Agenda Item #1

Application 2025-01-CA

1059 Elmira Street

Remove north portion of ancillary structure.
Construct new façade.

PROPOSED FRONT ELEVATION OVERLAY

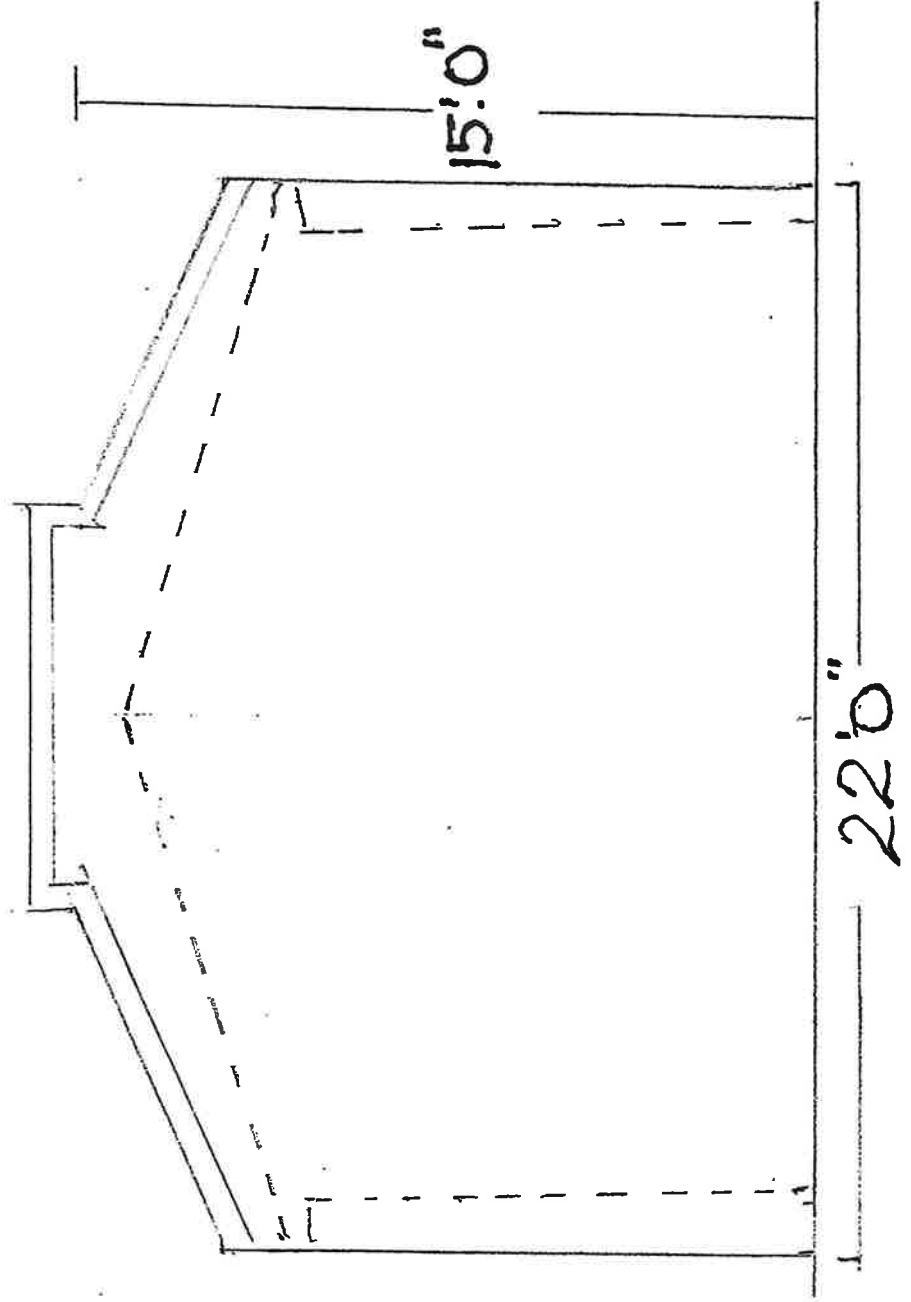
When rehabilitating a historic structure, the *Guidelines* recommend maintaining historic significant facades in their original form. If demolition of the front portion of the subject property is deemed appropriate, there will be no remaining historic façade to preserve. The remaining portion of the building is a later rear addition and therefore never had a street-facing façade. In this instance, the *Guidelines* do not support replication of the existing façade as this would place a ca. 1925 façade on a ca. 1956 addition. As proposed, the new façade design, with its lack of ornamentation and simple board-and-batten doors, is in keeping with mid-20th-century commercial construction. The proposed parapet design represents a departure from the front gable of both the existing

façade and the primary dwelling. However, there is neighborhood precedent for parapet walls on commercial structures, most notably at Callaghan's Irish Social Club (916 Charleston Street), which dates to roughly the same period as the ca. 1956 addition.

In reference to exterior cladding materials, the *Guidelines* prohibit replacing "building materials on the primary façade, such as wood siding and masonry, with alternative or imitation materials unless it cannot be avoided." The *Guidelines* further state that, if repair of the original material is impossible, a "substitute material may be considered if it appears similar in character and finish to the original." Therefore, while the *Guidelines* strongly discourage using fiber cement board on the primary façade of an existing structure, they do allow it where repair of the original material is not possible. The original wood siding on the c. 1925 structure is no longer extant, and the c. 1956 addition appears to have always been clad with corrugated metal sheets. A smooth fiber cement board that approximates the appearance of wood siding may therefore be appropriate, especially considering its use on an accessory structure that would sit behind the front plane of the primary dwelling.
